REMARKS

1. *Drawings*

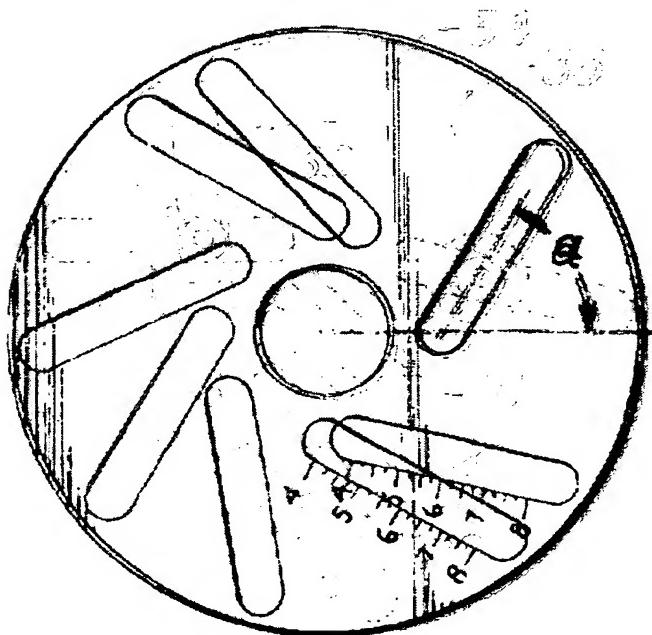
It is the Examiner's contention that the '911 *Warkotsch* reference supplies the missing limitation by disclosing a single mounting flange which singularly accommodates a plurality of lug hole spacings, i.e. a five-lug hole arrangement via holes 19, 20, and 21 (Fig. 1), and a 4-lug hole arrangements via holes 21'. Therefore, the Examiner contends it would have been obvious to one of ordinary skill in the art at the time of the invention to replace the individual mounting flange plates disclosed by the '128 *Mitchell* reference with the singular plate disclosed by the '911 *Warkotsch* reference in order to more conveniently accommodate different lug hole patterns on vehicle wheels.

A replacement of the individual mounting flange plates disclosed by the '128 *Mitchell* reference with the singular plate disclosed by the '911 *Warkotsch* reference, as suggested by the Examiner, would clearly result in a completely non-functional system. An illustration of what such a combined singular flange plate might look like, if using the designs shown in the '128 *Mitchell* reference, may be made by overlapping Figures 4,

5, and 6 of the '128 *Mitchell* reference as shown herein. As is clearly visible in this illustration, the tangential slot configurations of the '128 *Mitchell* reference, which are required to accommodate different lug patterns, cannot be combined on a single mounting flange, as slots for the different lug hole patterns would

intersect each other. Furthermore, the intended design of the '128 *Mitchell* reference, which requires that the underlying adjusting plate have corresponding slots which are

aligned perpendicular with the slots in the mounting flange plate, would have similar problems with intersecting slots, precluding the ability to radially move unobstructed passages (for mounting pins) to accommodate different diameter lug patterns by rotating the adjusting plate relative to the mounting flange plate.

FIG. 7A

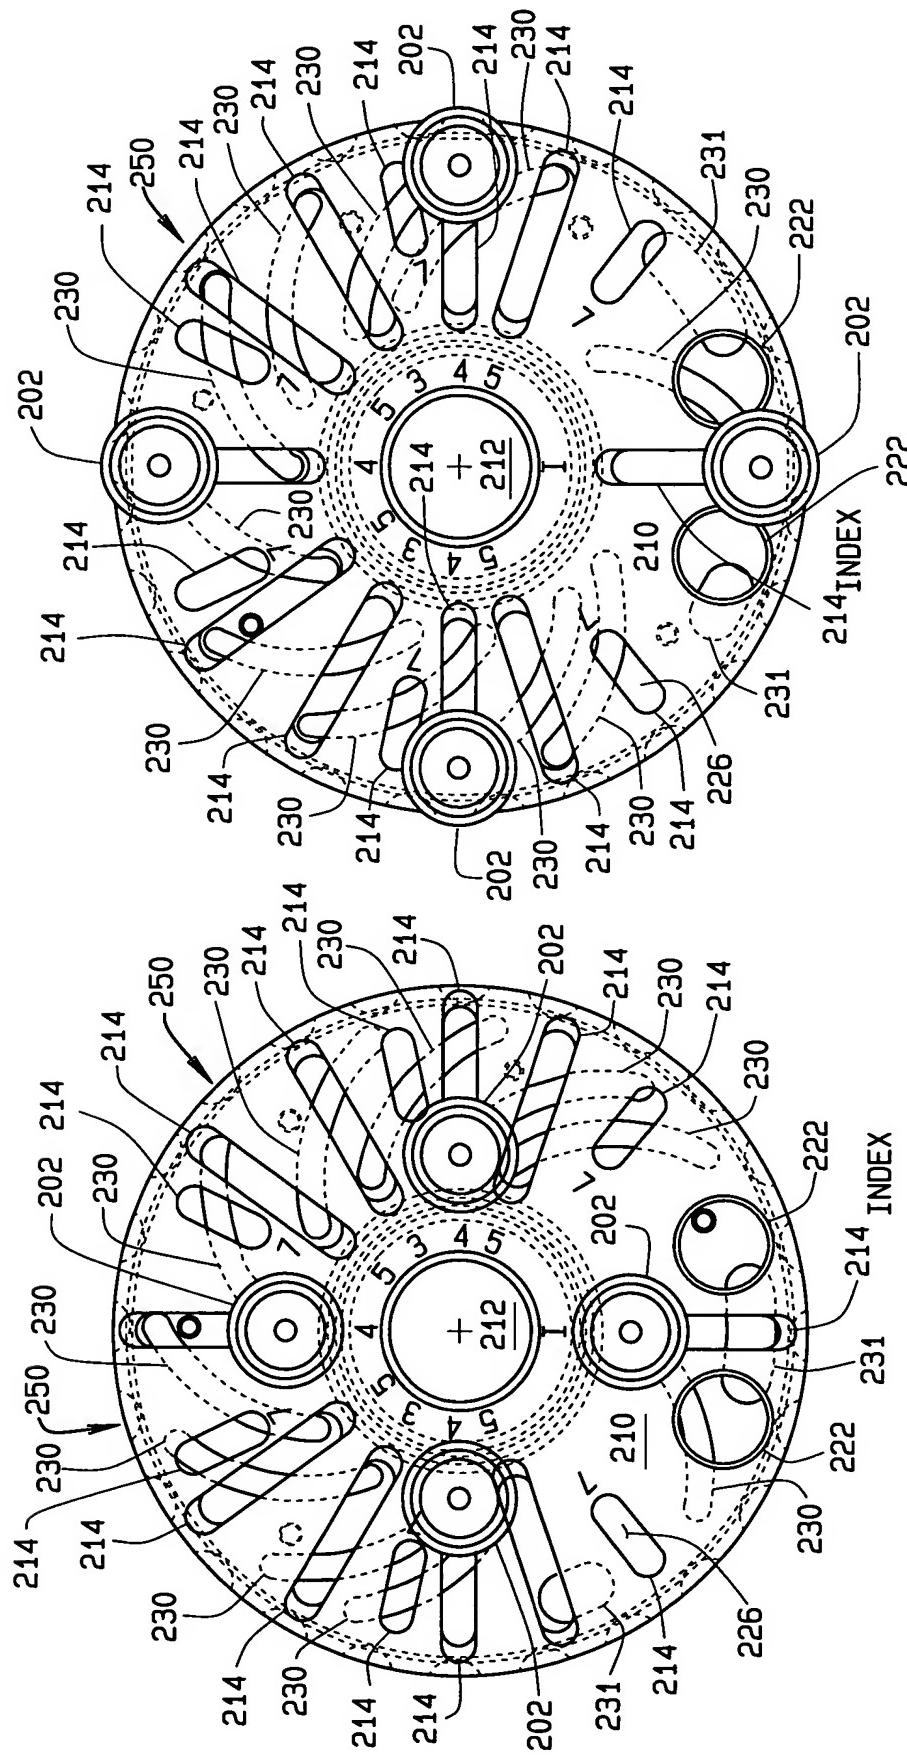
The Examiner has objected to the drawings under 37 CFR 1.83(a) as failing to show every feature of the invention specified in the claims. Specifically, the Examiner has stated that identifying indicia associated with each of the slots (i.e., "color, numbers, letters, or surface relief, as detailed in the specification) must be shown or the features cancelled from the claims. These features are set forth only in Claim 25.

The drawings have been amended such that an identifying indicia associated with the illustrated slots is shown. Specifically, identifying indicia in the form of numbers corresponding to subsets of slots (i.e. 3, 4, 5, and 7) have been added to Figures 7A and 7B where appropriate to identify slots comprising each subset. A clean set of the amended drawings and a marked up set illustrating the changes made have been provided. The use of numbers to identify subsets of slots is clearly described at Para. [0050] of the Specification, so the addition thereof to Figures 7A and 7B is not an entry of new matter.
